Service Bulletin

Bulletin No.: 16-NA-324

Subject: Small Holes Pierced into Sail Panel Area of Folding Top Cover, One/Both Sides

Brand:	Model:	Model Year:		VIN:		Engine:	Transmission:
		from	to	from	to		
Buick	Cascada	2016	2019			All	All
Holden

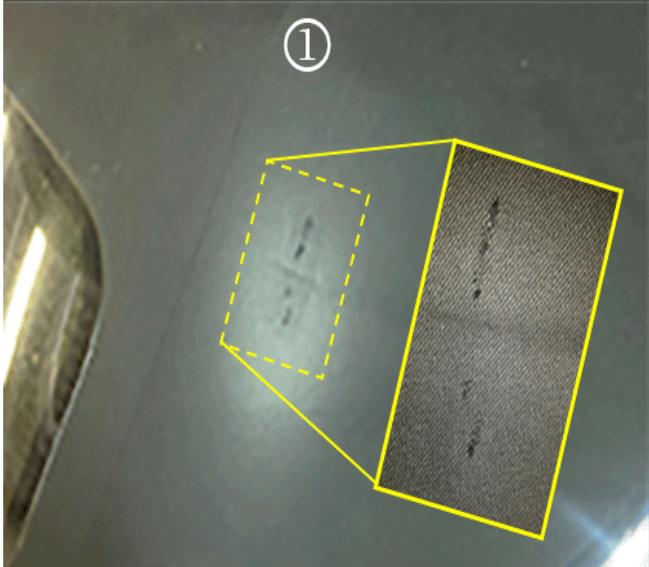
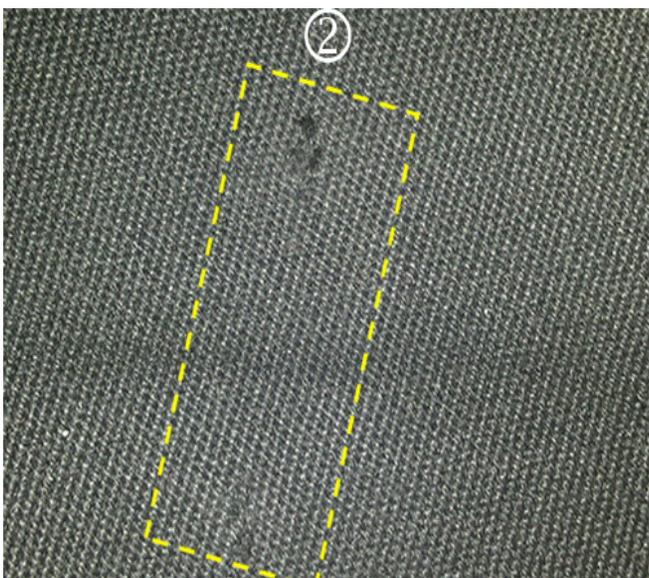
<p>Condition</p>	 <p>4585782</p>  <p>4585784</p> <p>Some customers may comment on seeing small pierced holes appearing in the sail panel area, on one or both sides of the folding top cover. Examples of right side (1) and left side (2) damage are shown in the graphics above.</p>
<p>Cause</p>	<p>The cause of the condition may be tension straps sewn into the top cover that were too long in length. This allowed the top cover material to fold into, and be pinched by, the kinematic hinge causing the wear/damage.</p>

Replace the folding top cover. Refer to *Folding Top Cover Replacement* in SI.
